Product Change Notification

Issue Date: September 15, 2015

Product Name: NANO-PV-D5252/D4252/N4552	Status: Running change								
Reason for Change Audio IC ALC888 and scalar IC NT68667UFG already have been EOL, and IEI has run out of the stocks of ALC888.									
Description of Change 1. Change Audio IC from ALC888 to ALC662. 2. Change Scalar IC from Novatek NT68667UFG to Novatek NT68660BUFG 3. Change BIOS from SA24AR12 to SA24AR15									
Affected Model

NANO-PV-D5252/D4252/N4552-R10

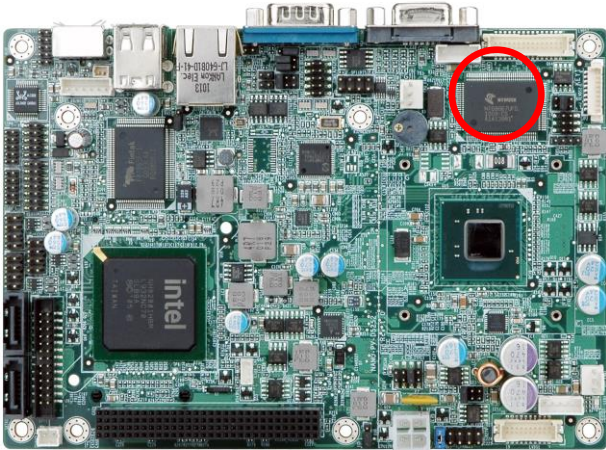
Original Scalar IC: Novatek NT68667UFG

Change Scalar IC to Novatek NT68660BUFG
Add Heatsink for Scalar IC
